ADDENDUM NO. 1
TO THE
DRAWINGS AND SPECIFICATIONS
FOR THE

KINSER PIKE SIDEWALK (GOURLEY PIKE TO 45/46 BYPASS)
PW 09-23

Kinser Pike Sidewalk Improvements at State Road 45/46 Bypass

Addendum No. 1 – Revised Plan Items and Alternate No. 1 Addition

Project No.:
6612
Date:
10-05-09
Drawing No.:
ADD1-C2

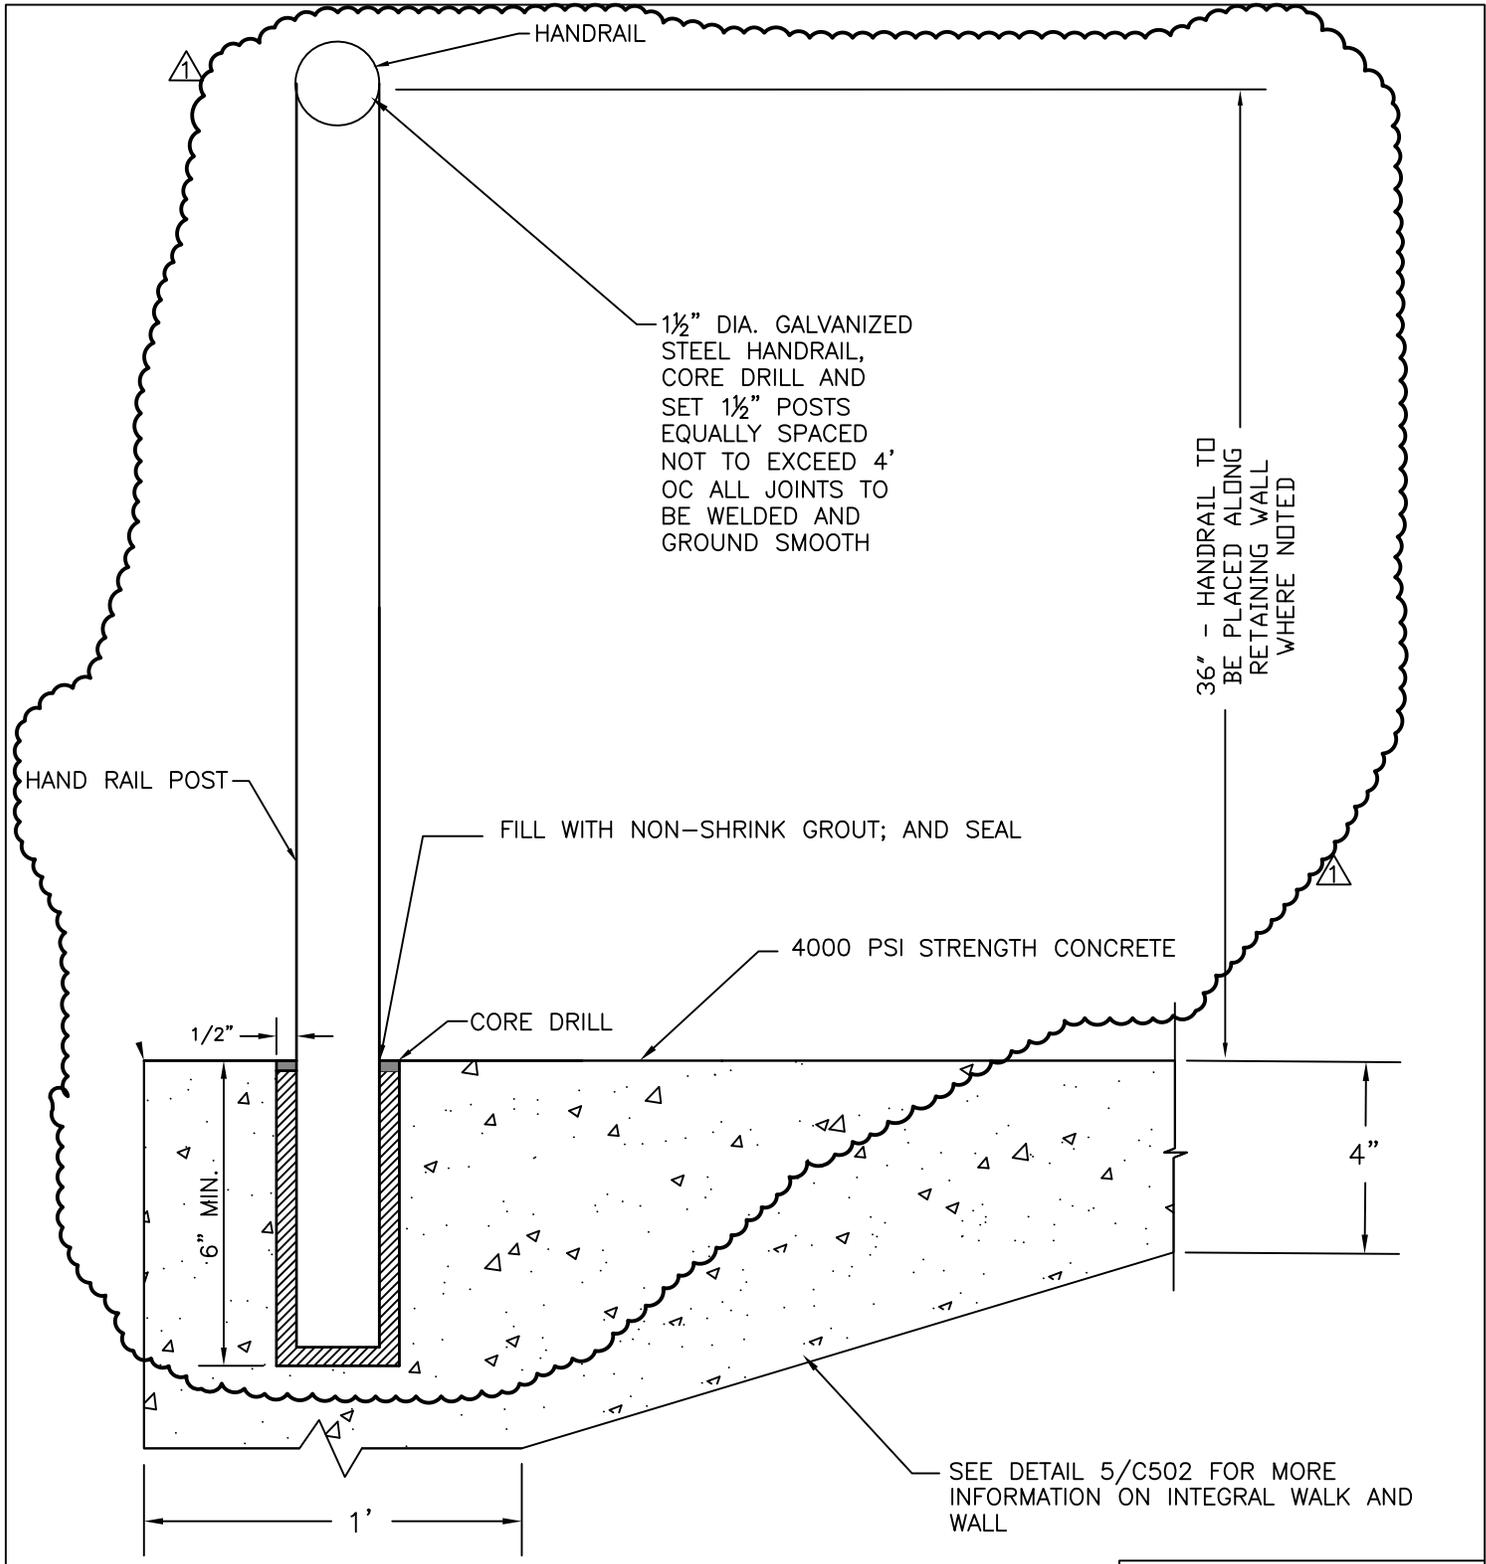
1. Contractor to revise plan note number 13 under Improvement Plan Notes on Sheet C201 to read, "PAVEMENT MARKING TRAFFIC PAINT - 6" WIDE, WHITE CROSS WALK PER INDOT SECTION 808.07."
2. Contractor to add storm structures and piping to plan as indicated on sheet ADD1-C1.
3. Contractor to provide alternate bid number 1. This alternate bid shall consist of the work to core drill concrete integral wall and walk, install hand railing along the entire length of the concrete integral wall and walk section, and seal all holes as indicated on sheet ADD1-C2.
